Dear Reviewer, first we want to thank you for your constructive, in-depth and clear questions and comments. Below you can find our answers point-by-point to your comments. We also highlight (where possible) the part of the original submitted manuscript that have been modified to address your comments. To facilitate the reading, we added our responses to your comments in red. If changes to the text are proposed, changes are underlined.

Major Reviews:

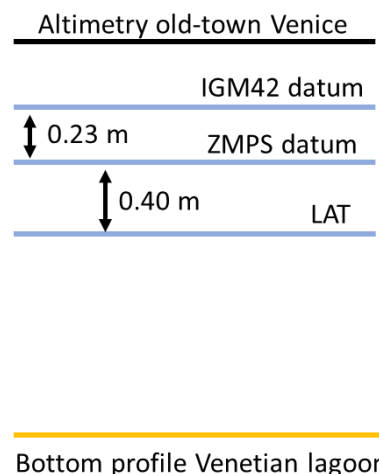
Regarding the altimetry data that has been used in this study, has the correction to the ZMPS datum been done within the work developed in this manuscript or is it a data that has been obtained as already published from other sources? If the correction to the reference ZMPS level has been done as part of the work developed in this manuscript, please add a methodological description on how this has been performed (I suggest adding it in the supplementary material if possible).

The correction to ZMPS datum has been done within this work. We added a new sub-section “Conversion of altimetry data” and add an explanatory schematisation:

“Altimetry data were derived from various sources with varying reference datum as shown in Tab.2 of the main paper. Conversion of the altimetry to the ZMPS datum were performed by adding or subtracting the absolute difference between the respective datum and ZMPS as conceptualised in Fig. X. Accordingly, the bathymetry information of the Venetian lagoon and the canals within the old-town (both available in IGM42, where 0m IGM42 corresponds to + 0.23 m ZMP) were corrected by subtracting 0.23cm from the original IGM42-referenced altimetry data. The surface of the old-town of Venice (also provided in IGM42) was corrected by adding 0.23 cm given that the surface was generally located above the respective MSL. Altimetry information of the Adriatic shelf were provided with reference to the LAT datum which was assumed in this work to approximately correspond to -0.4m ZMPS. Consequently, bathymetry of the Adriatic shelf was corrected by adding +0.4 m.”
